CASE COMMENT REPORT

CASE NO. UDP-S25013

CASE	UDP-S25013
PROJECT NAME	New Aircraft Hangar - FXE
APPLICATION TYPE	Site Plan Level II
APPROVAL LEVEL	Development Review Committee
REQUEST	20,375 Square-Foot Aircraft Hangar
APPLICANT	City of Fort Lauderdale FXE Airport
AGENT	Robert Allica, Allica Architectural Group
PROPERTY ADDRESS	5601 NW 15th Avenue
ABBREVIATED LEGAL DESCRIPTION	F-X-E Plat 119-4 B A Por Tr 1, Lying Partly in Sw1/4 Of Se1/4 & Se1/4 Of Sw1/4 Of Sec 9
ZONING DISTRICT	General Aviation Airport (GAA) District
LAND USE	Transportation
COMMISSION DISTRICT	1 – John Herbst
NEIGHBORHOOD ASSOCIATION	N/A
SUBMITTED	April 12, 2025
COMPLETENESS ISSUED	April 23, 2025
EXPIRATION	August 21, 2025 (120 Days)
WAIVER	Not Requested
CASE PLANNER	Michael Ferrera, Urban Planner II

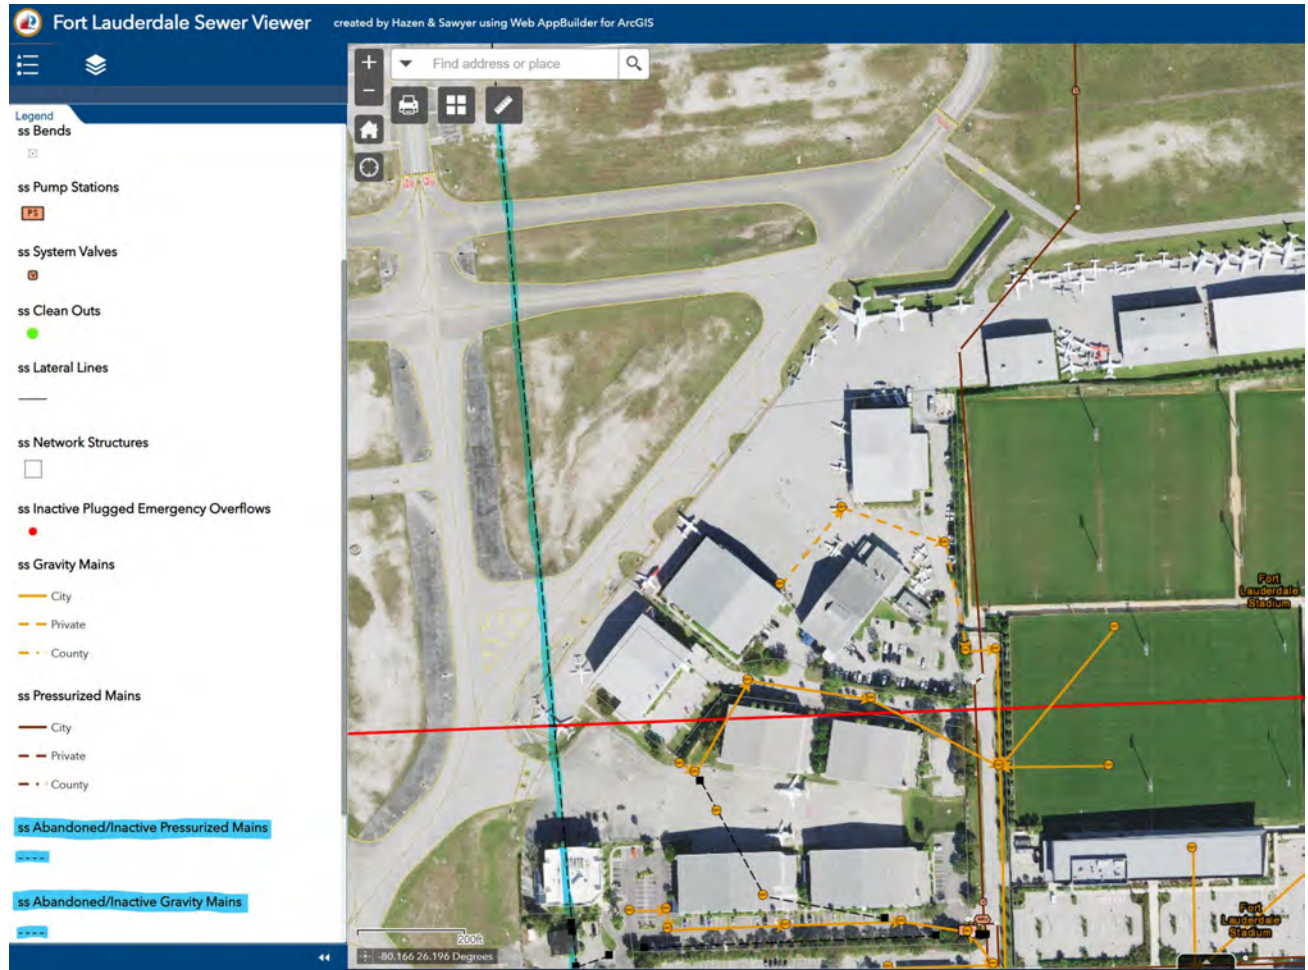
7. Sheet C1.1/Existing Conditions and SWPPP Plan: Show/label what appears to be an 'Abandoned/Inactive' 10" Cast Iron sewer force main pipe, per the City's Atlas Maps. For a visual, the following image (snipped from the City's GIS Sewer Viewer) highlights this pipe in light blue:
